CALIFORNIA COASTAL COMMISSION

SUBJECT: Major Amendment Request No. 2-98A to the City of Long Beach Certified Local Coastal Program (For Public Hearing and Commission Action at the August 13, 1998 meeting in Huntington Beach).

SUMMARY OF LCP AMENDMENT REQUEST

EXHIBIT # 9

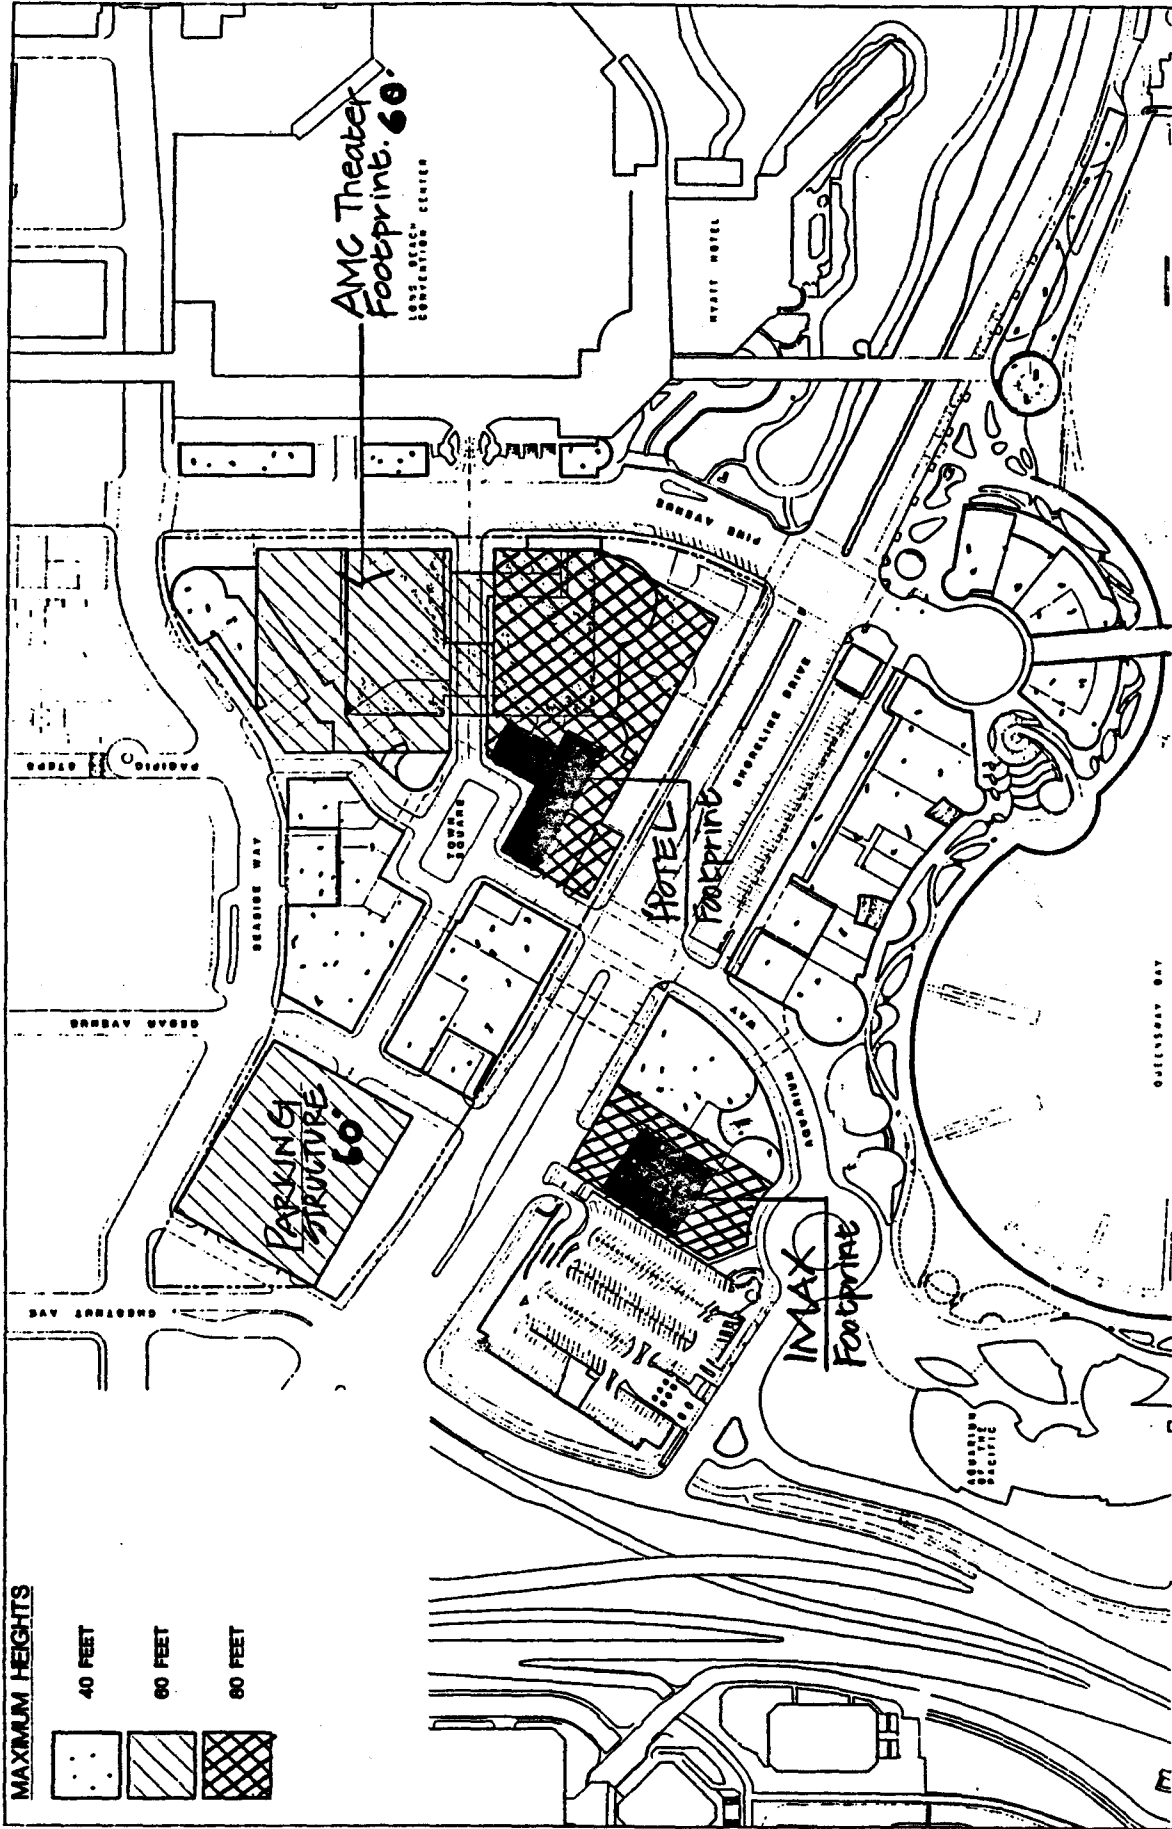
- a. Revise view corridor standards, including the reduction of the existing 150 foot wide view corridor at the intersection of Shoreline Drive and Aquarium Way to 60 feet (Exhibits #10&11: View Corridors).
- b. Increase the general building height limit from 35 feet to 40 feet.
- c. Allow an 80 foot high large format theater (IMAX/IWORKS) on the waterfront, partially within a protected view corridor (Exhibit #9).

SUBAREA 6 - VIEW CORRIDORS
DIAGRAM A

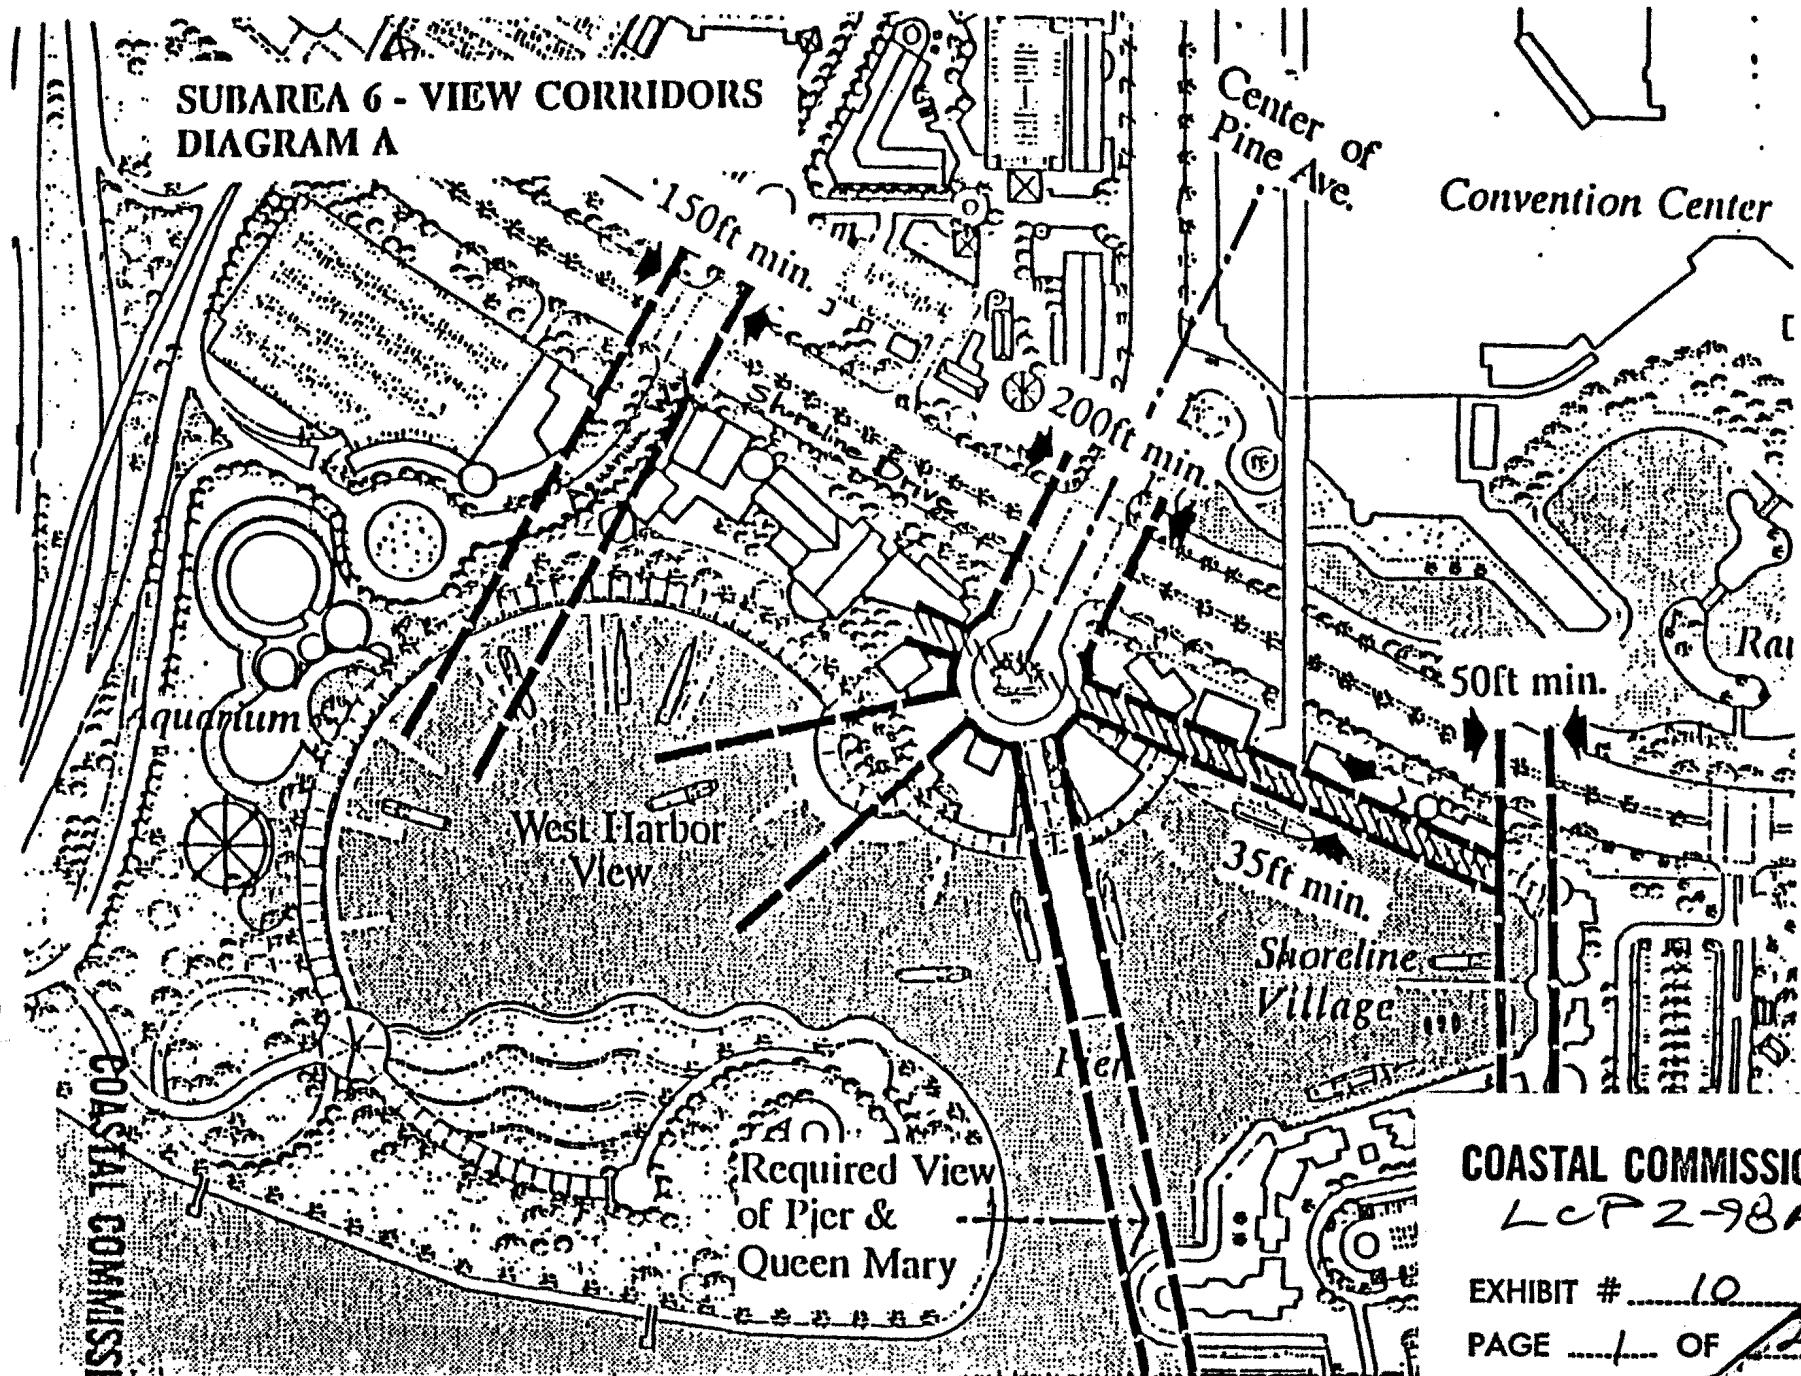
The 410 foot long view corridor/open space area on Shoreline Wharf is proposed as part of the LIP amendment request (Exhibit #11). In order to protect the 410 foot long view corridor and open space area, no new buildings may be permitted in this area. Therefore, a modification is necessary to protect this newly designated open space area. Only if modified as suggested will the proposed LIP amendment be in conformance with, and adequate to carry out, the provisions of the certified LUP.

Shoreline Drive. If a view corridor/open space area at least 150 feet wide is not provided from the intersection of Shoreline Drive and Aquarium Way to Rainbow Harbor (as formerly required by the certified LCP), then a pedestrian bridge connecting Subareas 5 and 6 shall be provided over Shoreline Drive. The bridge shall be at least 25 feet wide and be at the same level as the public viewing deck provided between Aquarium Way and the parking structure in Subarea 6. The bridge shall be designed to provide open views to Rainbow Harbor and the Queen Mary which open up as one crosses the bridge from the north to the south. To protect the views from and through the bridge, all railings and decorations on the bridge shall be limited to a height of four feet measured from the pedestrian deck.

5. Public viewing deck. If a view corridor/open space area at least 150 feet wide is not provided from the intersection of Shoreline Drive and Aquarium Way to Rainbow Harbor (as formerly required by the certified LCP), then a public viewing deck with a minimum of 35,000 square feet of usable public area shall be provided on the second level of the building or buildings located between the aquarium parking structure and Aquarium Way. The public viewing deck shall be designed and oriented to provide open views to Rainbow Harbor and the Queen Mary, and shall be available for public use, including picnics, as public parks are. Park benches and tables for eating shall be provided for general public use on the viewing deck. Take-out and walk-up food services are encouraged behind the viewing deck, but restaurant table service is prohibited. All structures in Subarea 6 shall be designed and sited to protect the public views to Rainbow Harbor and the Queen Mary from the public viewing deck.
